PARTIAL ANCHOR BOLT SETTING PLAN (LEVEL-M3) (SECTOR-A)
(REFER SHEET: S-A-2522)

PARTIAL ANCHOR BOLT SETTING PLAN (LEVEL-M3) (SECTOR-A)
(REFER SHEET: S-A-2512 & S-A-2534)

ANCHOR BOLT SETTING KEY PLAN (SECTOR A-B-C)

DATE	NO.	DESCRIPTION	PAR	220	S.I
06/21/2022	B	FOR RE-APPROVAL		BOULONS A325N	S.I
06/01/2022	A	FOR APPROVAL		PEINTURE 1.721A PRIMER	S.I

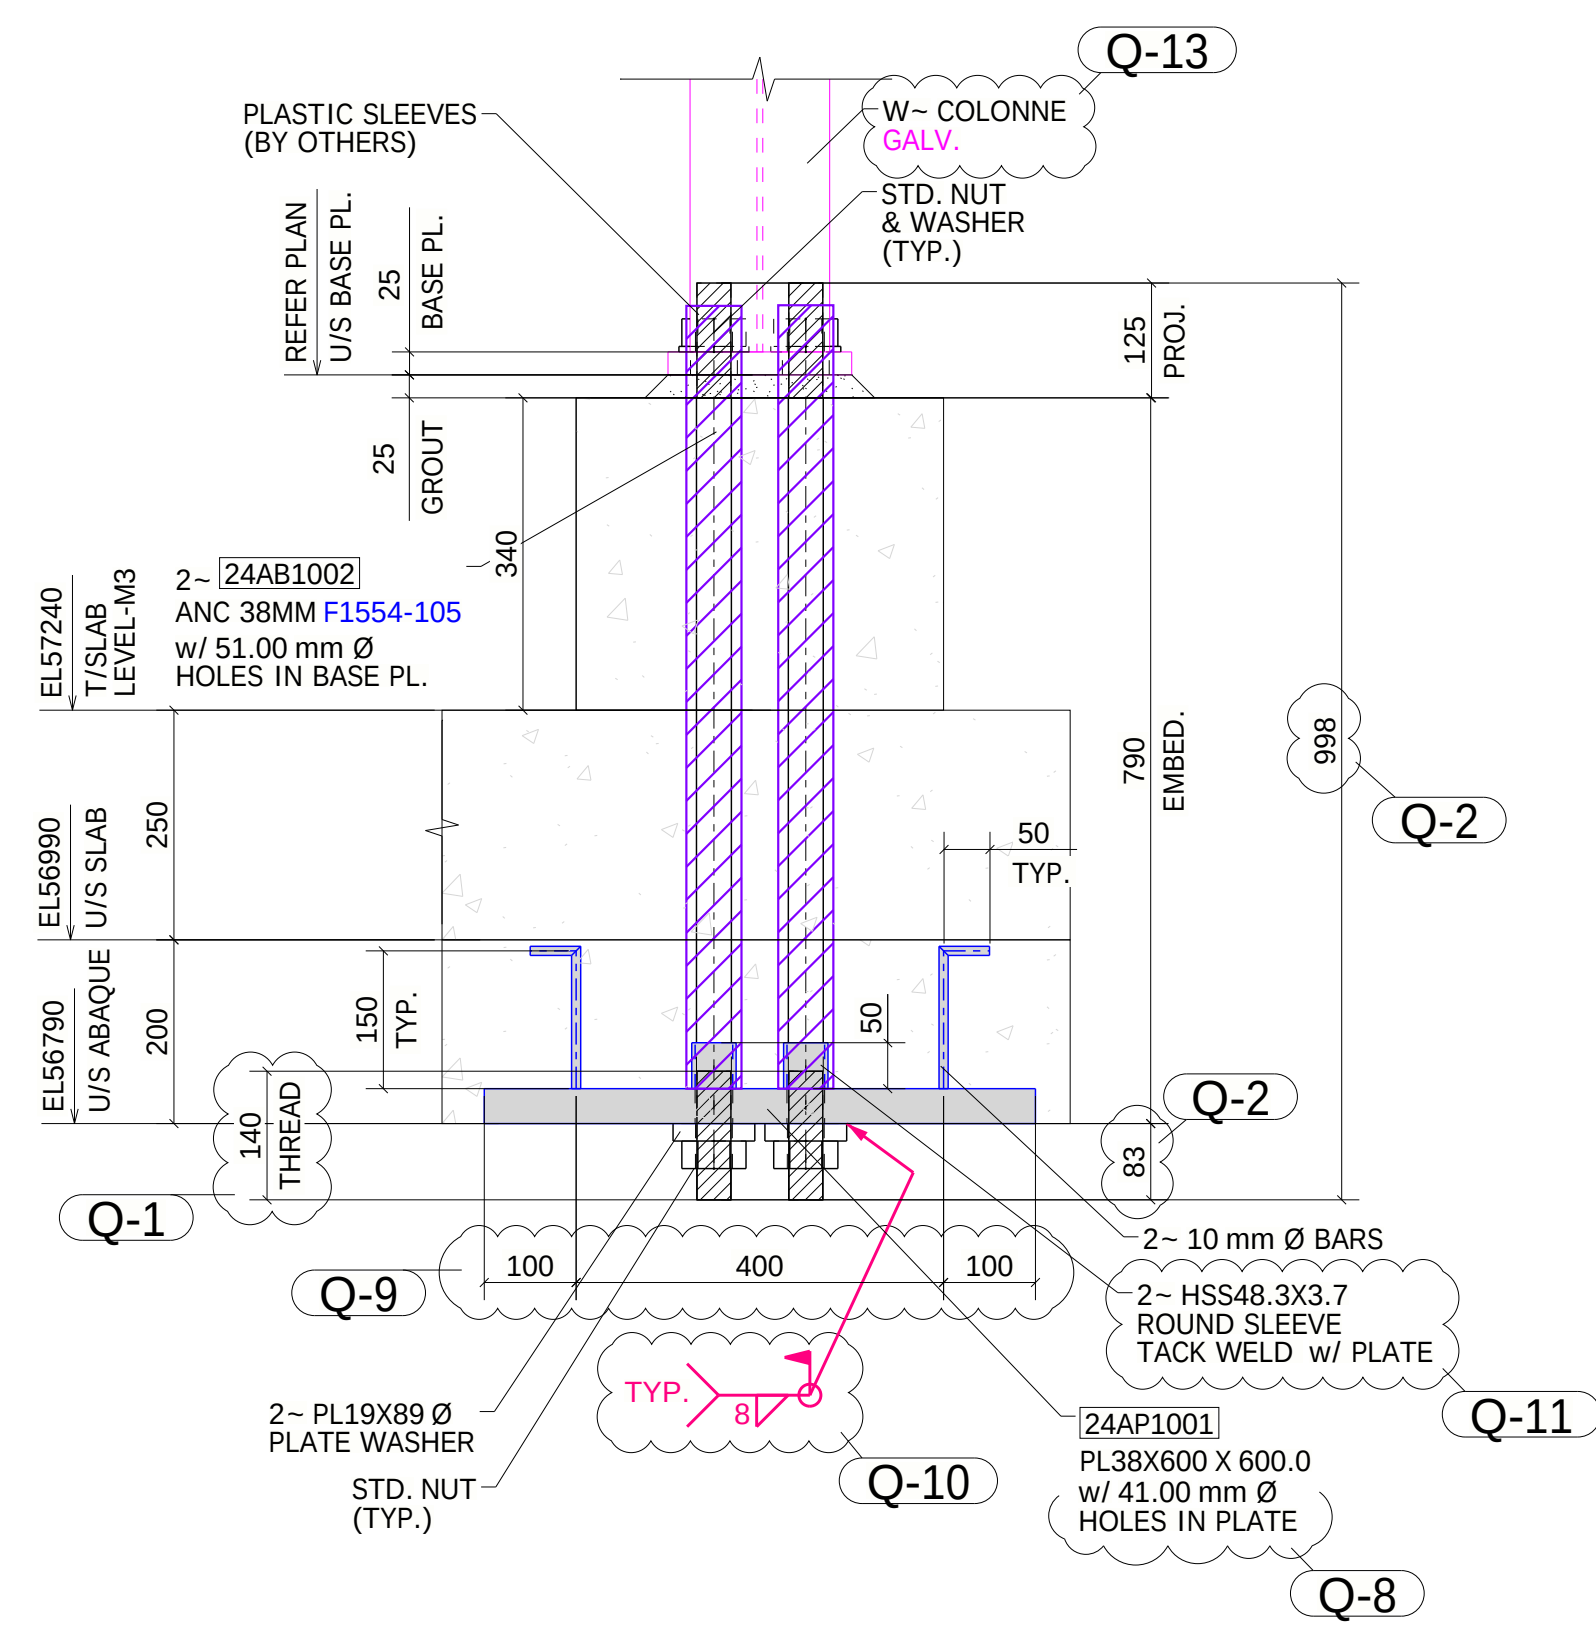
APPROVER VERIFY BASE PLATE TYPE USED AT THIS LOCATIONS.
SINCE STRL.SHEETS DOES NOT HAVE CLEAR INFORMATION.

APPROVER VERIFY COLUMN LOCATING DIMENSIONS.
SINCE STRL.SHEETS DOES NOT HAVE CLEAR INFORMATION.

APPROVER VERIFY BASE PLATE TYPE FOLLOWED (TYPE PL-6) WITH EMBEDMENT OF 300mm AT THIS LOCATION. SINCE WE ARE HAVING ONLY 250mm THICK SLAB. PLEASE SUGGEST HOW TO PROCEED WITH ANCHOR ROD LENGTH.

APPROVER VERIFY U/S OF BASE PL. ELEVATION.SINCE
STRL. PLAN (S-A-2523) DOES NOT SHOWS ANY PIER
AT THIS LOCATION. PLEASE VERIFY AND CONFIRM.

APPROVER VERIFY ALL UNDER SIDE OF
BASE PLATE ELEVATION,TYPE & ORIENTATION.

APPROVER VERIFY/FURNISH
ALL CLOUDED INFORMATIONS
